Value Engineering Study  
Report

**KY 536 EXTENSION – 6-352.00**

**VE Number: 202501**

**Report Date: April, 2025**

**Realign 536 closer to Stonehouse Road**

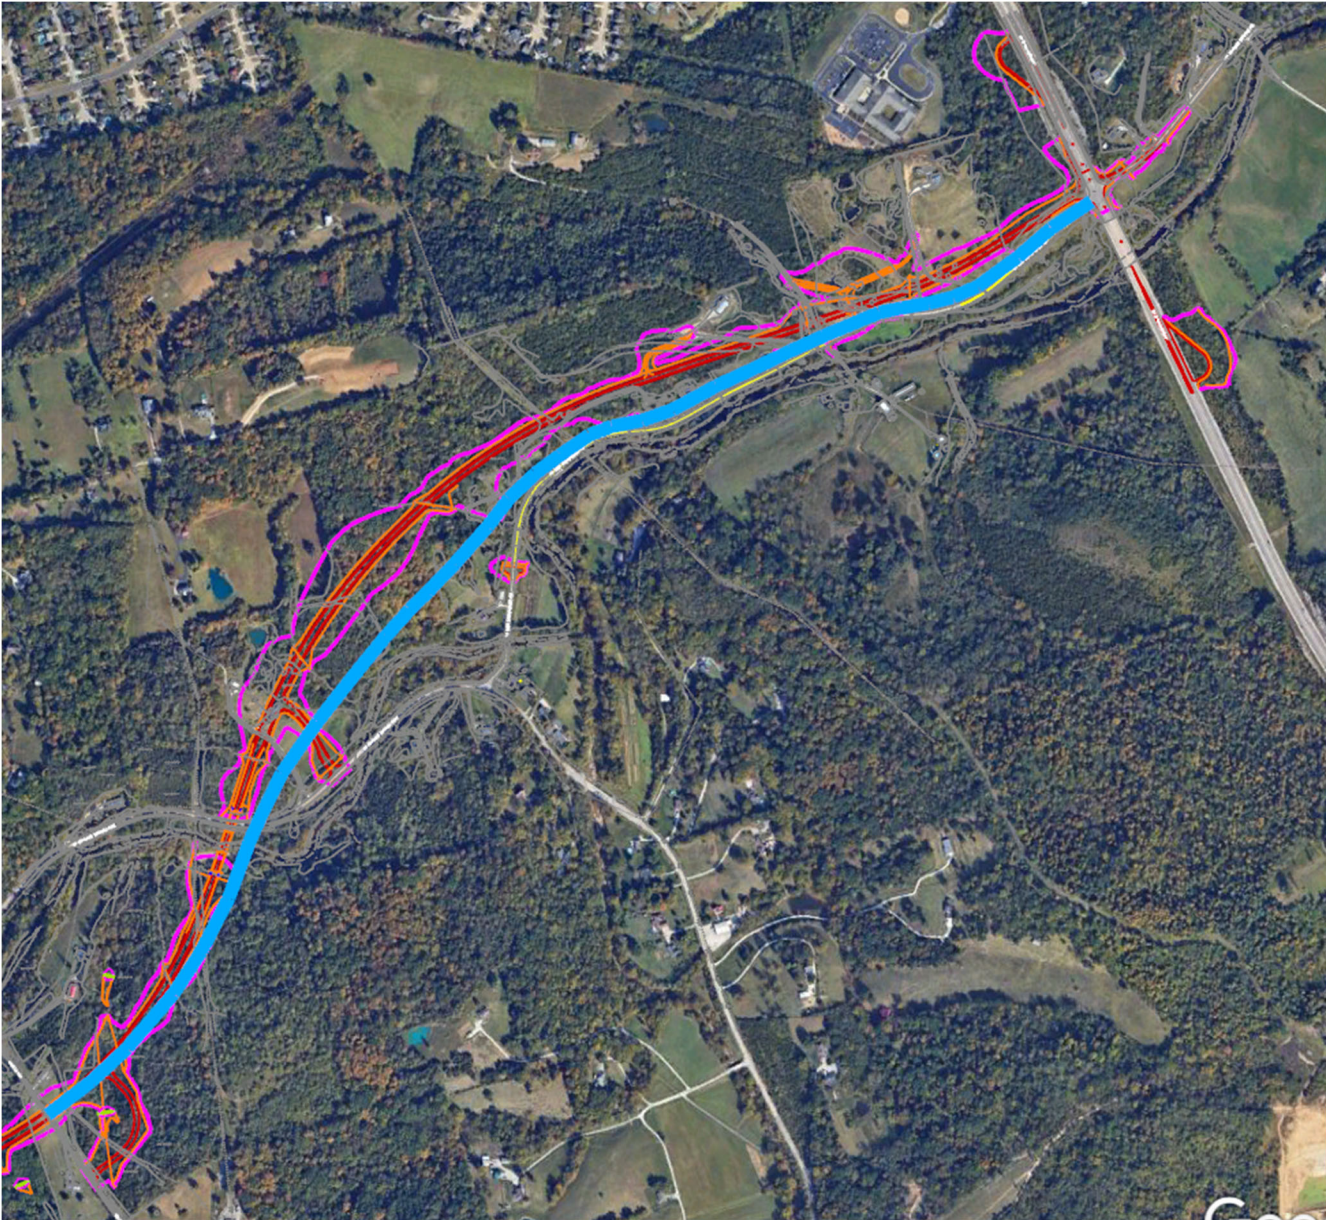
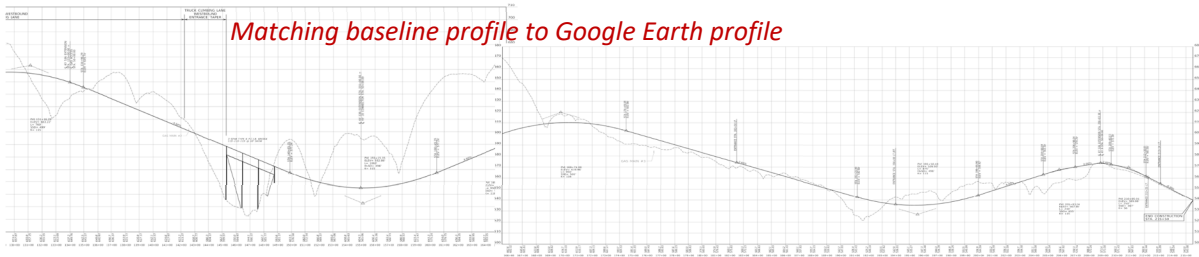
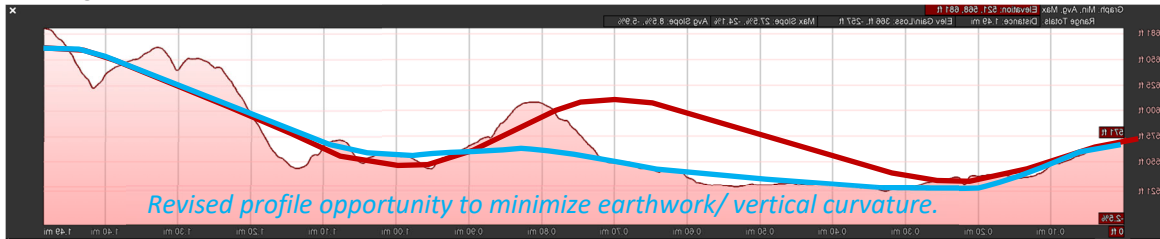
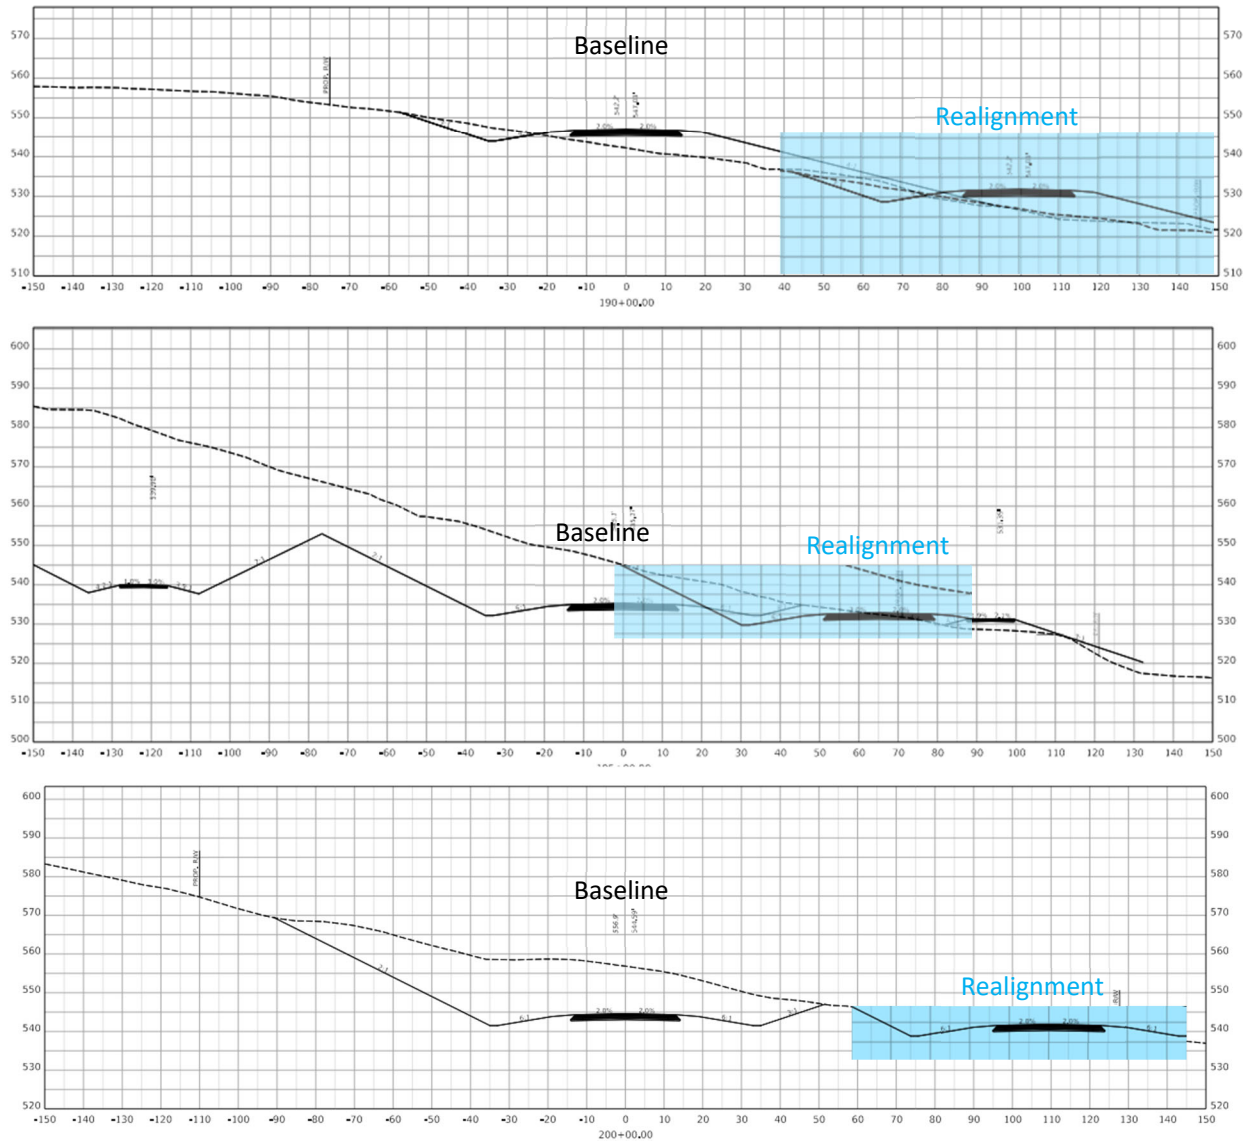
| <b>Attributes and Rating Rationale</b>  |
|---|
| <b>Mainline Operations</b><br>Negligible change.<br>Reduction in vertical profile with additional horizontal curvature introduced.  |
| <b>Local Operations</b><br>Negligible change.<br>Maintains alignment close to Stonehouse which reduces local connection lengths. Improves the alignment at the intersection with KY9. |

*Matching baseline profile to Google Earth profile*

*Revised profile opportunity to minimize earthwork/ vertical curvature.*

### Reduce profiles throughout and increase roadway grades

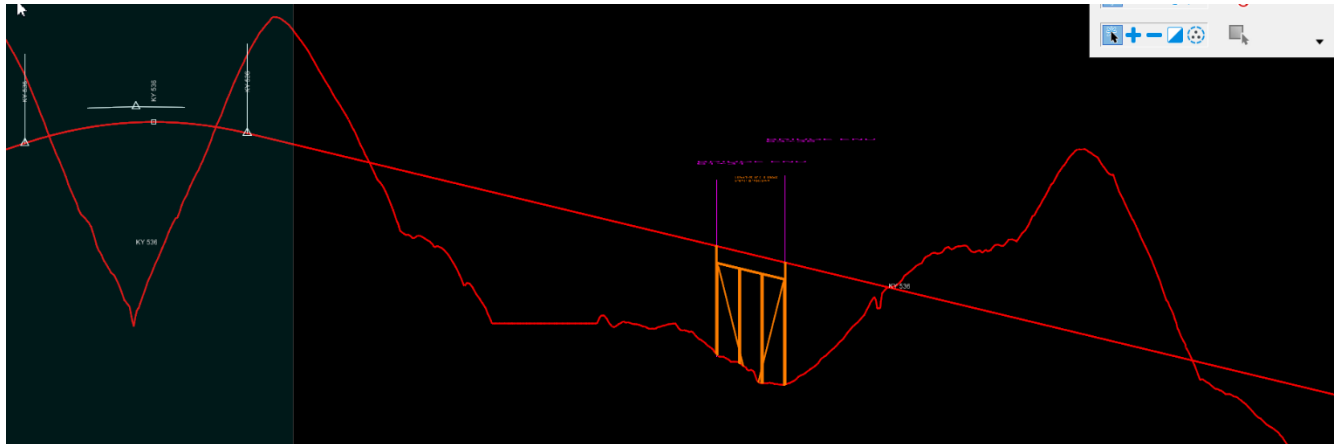
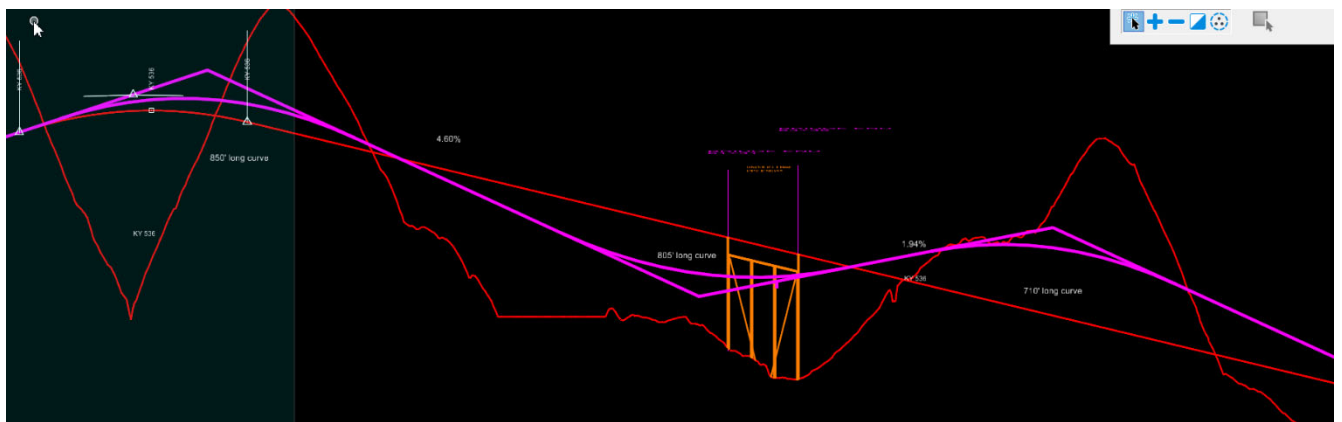
The alternative is to revise the profile by increasing the grade in areas where flatter slopes were utilized as well as optimizing vertical curves based on the increased grades.

- Assumed vertical curve lengths as labeled in the drawing above.
- Calculations are based on a percent reduction in profile area.

| Alt No. | Alternative Title   | Implement Status | Decision Rationale / Comments  |
|---------|---|------------------|--|
| PX-1    | Reduce profiles throughout and increase roadway grades    | A                | Redesign required. Please note that these vertical changes to minimize earthwork will result in additional segments of the corridor that will show significant truck speed reduction and/or have steep grades on both sides of proposed intersections. And will also require additional work at the intersections.   |

### Reduce footprint with steeper side slopes

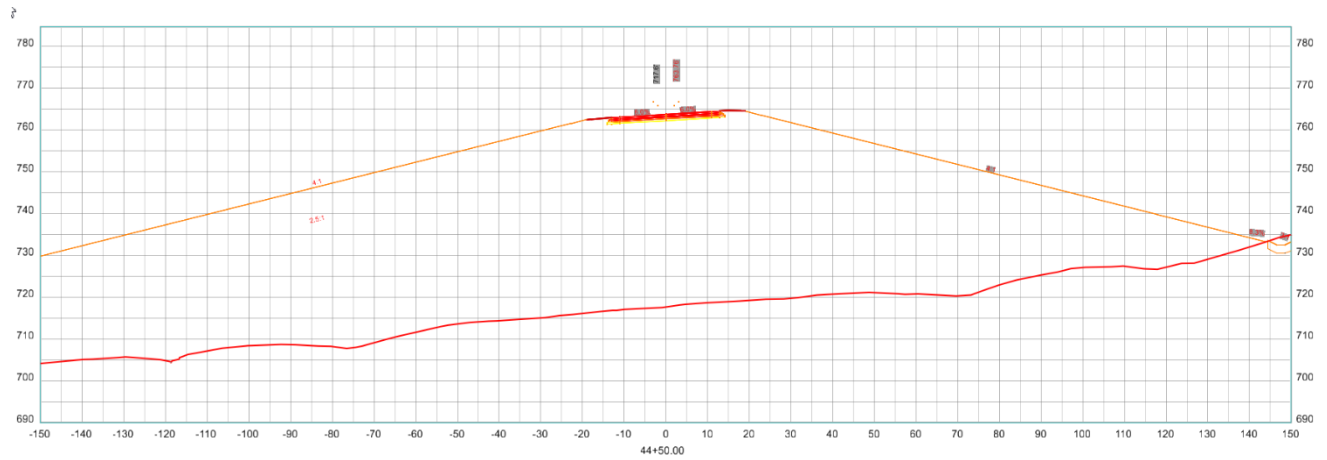
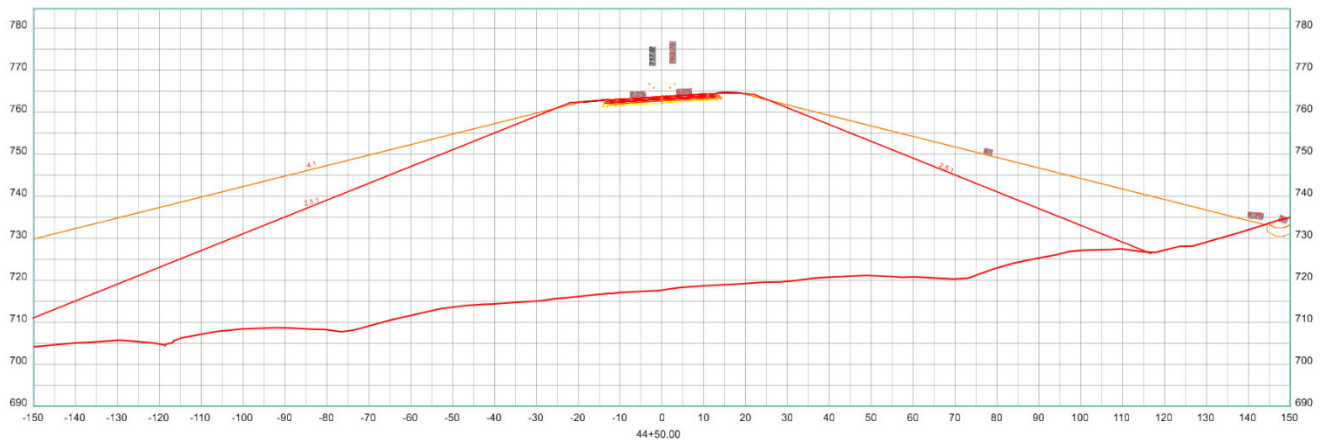
- Assumed Locations
  - Station 26+00 to 31+50, assumed depth of 40 ft
  - Station 40+00 to 46+00, assumed depth of 50 ft
  - Station 106+50 to 124+00, assumed depth of 20' over a ridge
  - Station 132+00 to 133+00, assumed depth of 35'

### Adjust profile and eliminate truck climbing lane

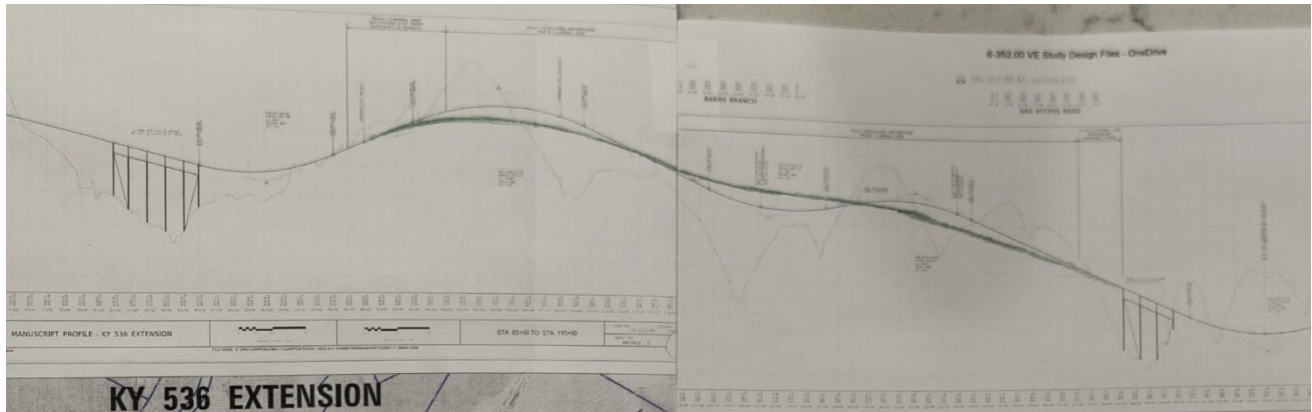
- Does not provide a parking area for emergency situations in addition to the truck climbing lane.
- Less recovery and emergency refuge area.

### Reduce shoulders at truck climbing lane

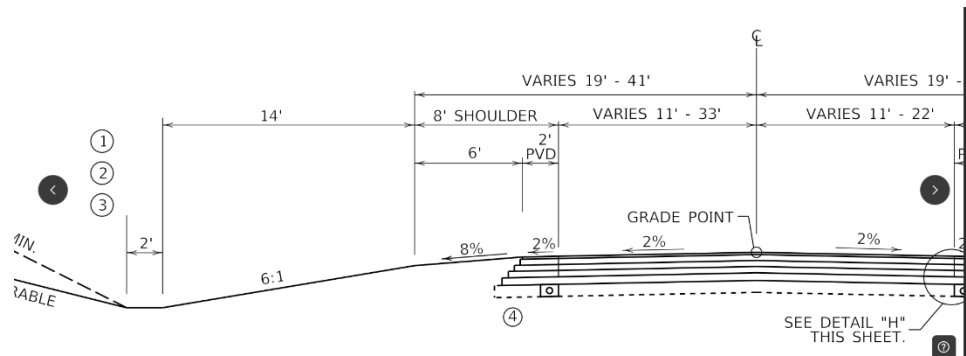
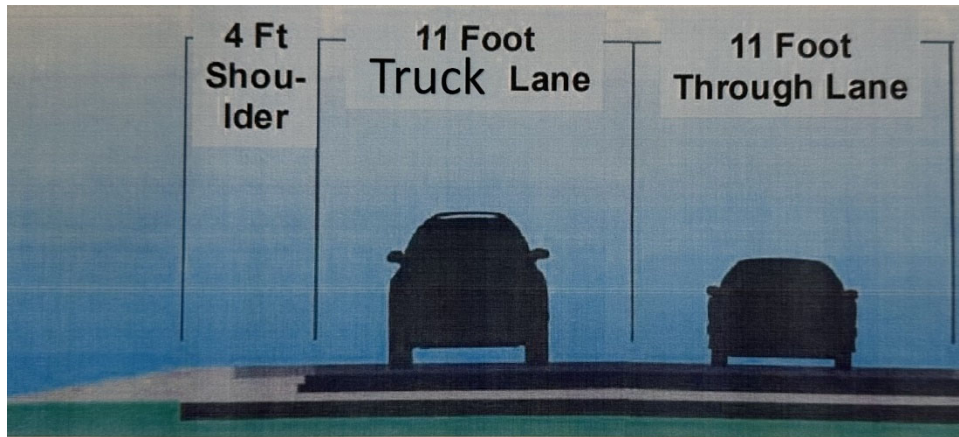
Reduces net earthwork by approximately 7,500 CUYD

### Realign culverts and shorten structure lengths/size

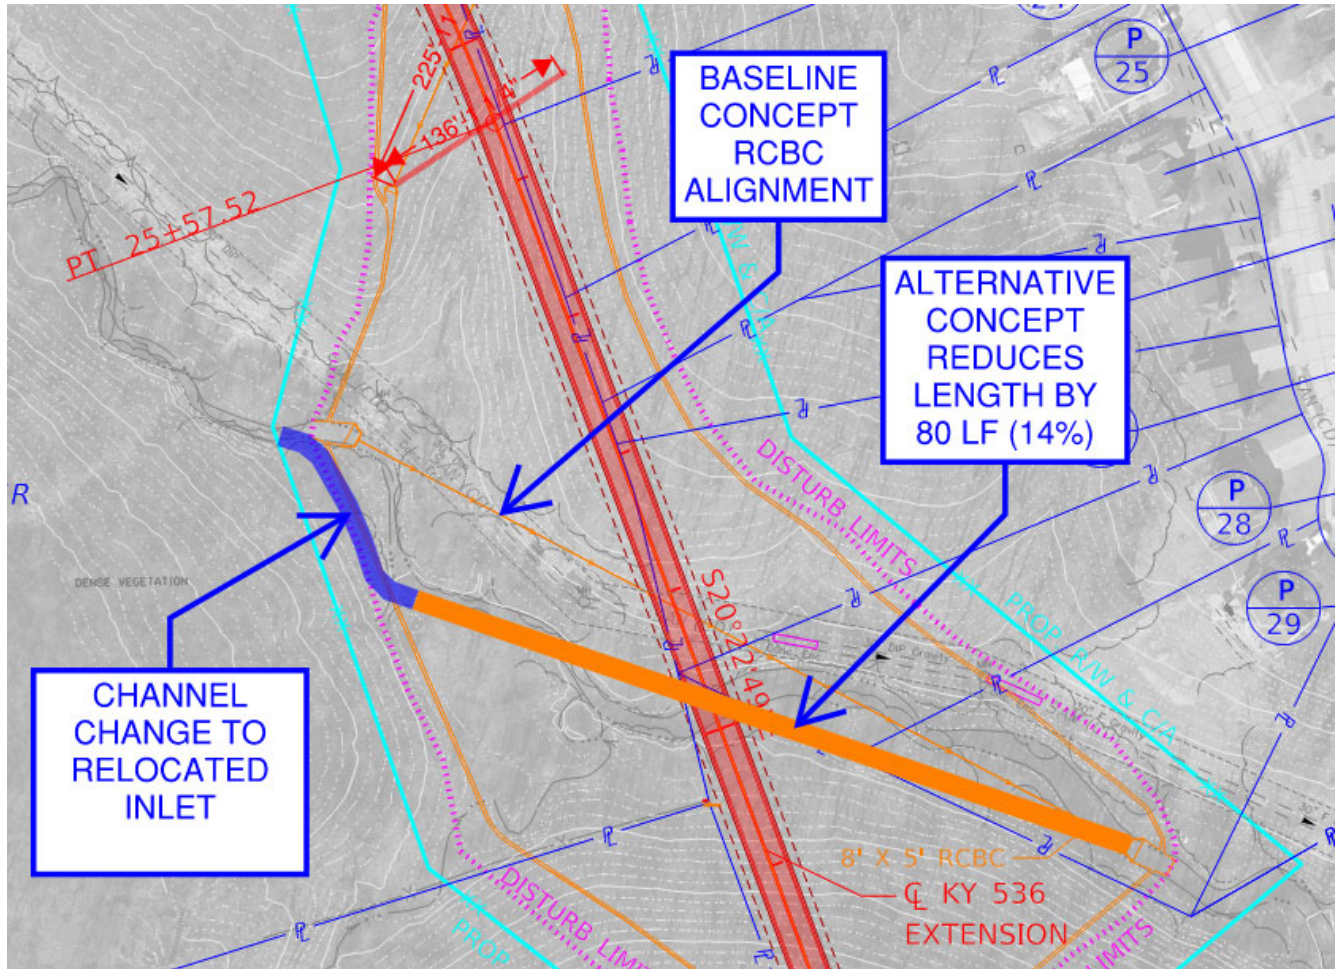
The alternative concept looked throughout the project for the best opportunities to realign culverts to more of a perpendicular crossing. This typically creates additional earthwork for ditching and some channel change for larger structures in streams. For this alternative, culverts larger than 36" diameter were considered to be on a stream.

The handful of locations listed below were identified as potential culvert crossings that could be realigned and provide shorter lengths to provide cost savings to the project. This is without adjusting the side slopes and just using a more perpendicular crossing or otherwise relocating the inlet. Other culverts not listed here could still be revisited for final design. A sketch is only provided for the 8'x5' RCBC, but stations and brief description is provided below.

Sta. 29+00 – 8'x5' RCBC; Base 595 LF, Alternative 515 LF and 115 LF of minor channel change.

| Attributes and Rating Rationale  |
|--|
| <b>Environmental Impacts</b><br>For the list provided above, only the box culvert is considered on a stream. Relocating the inlet creates the need for a section of channel relocation, however that work could be eliminated with a "barn roof" roadway side slope. For the alternative concept, the cost associated with stream impact will be included. |

**Reduce thickness of AC pavement in typical structural section**

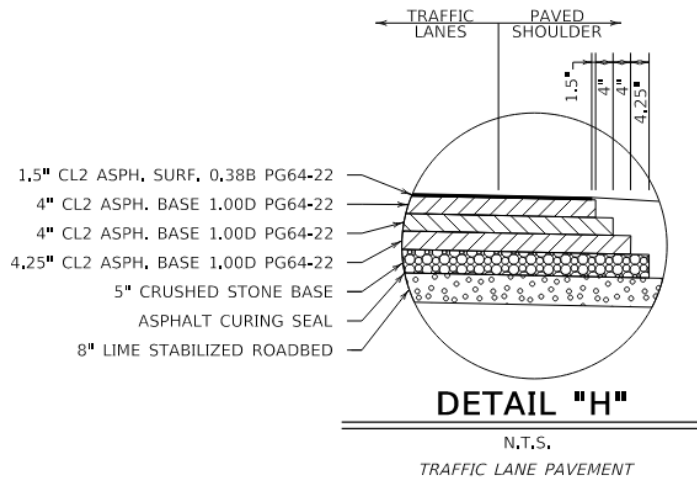
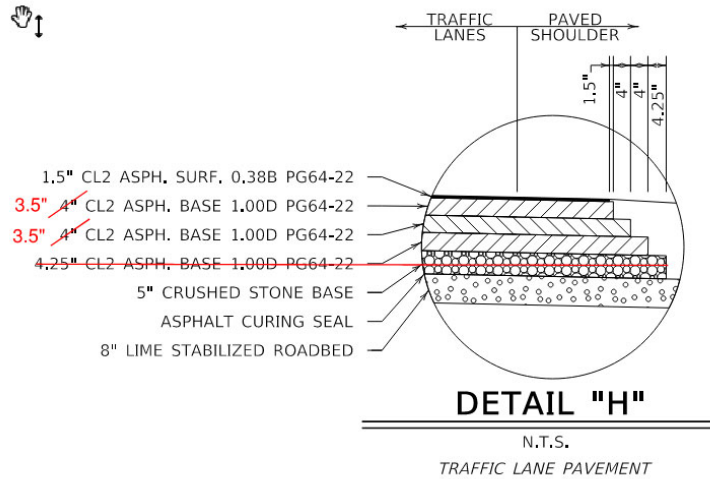
- Assumed CBR of 1
- Assumed T% of 5% but later increased to 8% to be conservative.
